Groundwater Transfer Review Summary Form

Transfer/PA # T- 13360

Application: T-13360

Applicant Name: Osprey Corner, LLC

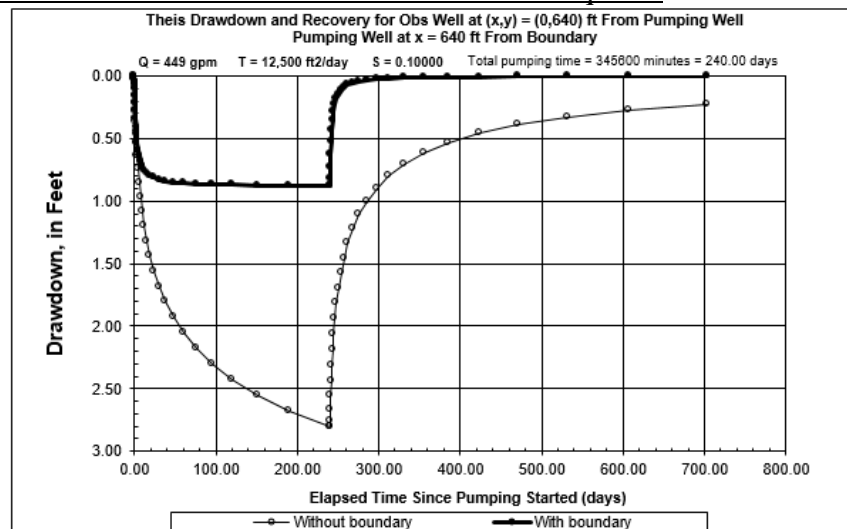
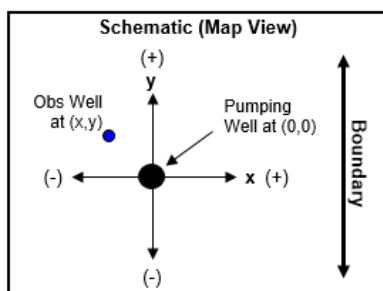
The application notes that GR-207 & referenced GR-2193 appear to have referenced well and POU locations by incorrectly assuming that the NE corner of Section 14 was at the NW corner of Weddle Road and that the north-south portion of Weddle Road was the section line between sections 13 and 14. We agree that this is true based on a review of information in files GR-207 and GR-2193 and on the registration statements. All well locations on the enclosed map reflect the best known locations of the 4 authorized POAs and the 2 proposed APOAs.
